MANUAL HARD COPY DISTRIBUTION
DOCUMENT TRANSMITTAL 2004-48843

TRM2 - TECHNICAL REQUIREMENTS MANUAL UNIT 2

Manual Title: TECHNICAL REQUIREMENTS MANUAL UNIT 2

SUSQUEHANNA STEAM ELECTRIC STATION
LIST OF EFFECTIVE SECTIONS (TECHNICAL REQUIREMENTS MANUAL)

MCPR OPERATING LIMIT VERSUS CORE POWER
EOC-RPT AND MAIN TURBINE BYPASS OPERABLE
TWO LOOP OPERATION (BOC TO EOC)
FIGURE 5.2-2

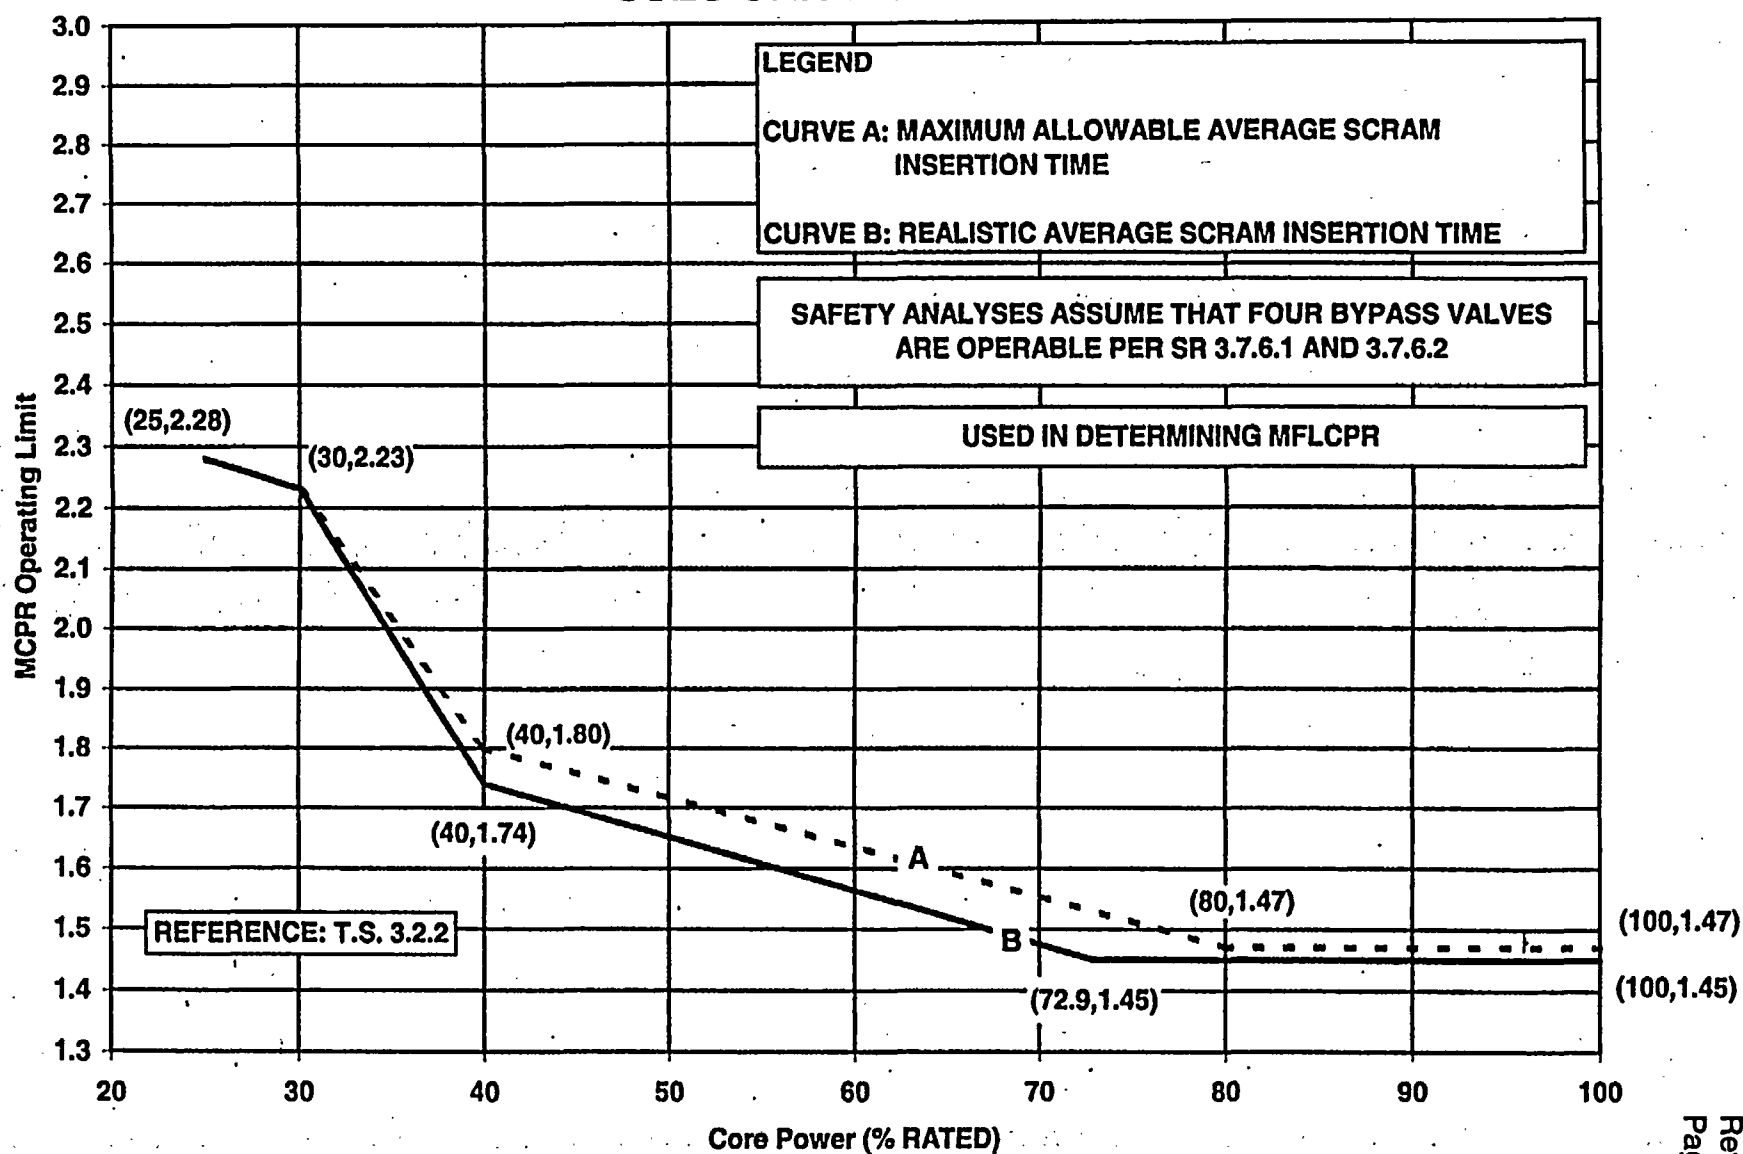
3	5.0 8.0 10.0	The figures within Section 5.0 and Section 8.0 are revised to incorporate the 0.02 MCPR Safety Limit reduction approved by Amendment No. 191. Figure 5.2-2 is revised to correct the Operating Limit error documented by CR 606127.
4	TOC 1.0 2.0 9.0 10.0 11.0	This revision changes the Power / Flow map and adds setpoints for the OPRM system. The change to the Power / Flow map provides direction when the OPRM system is OPERABLE and inoperable. The setpoints for the OPRM system are set to reliably detect and suppress anticipated stability related power oscillations while providing a high degree of confidence that the MCPR safety limit is not violated.
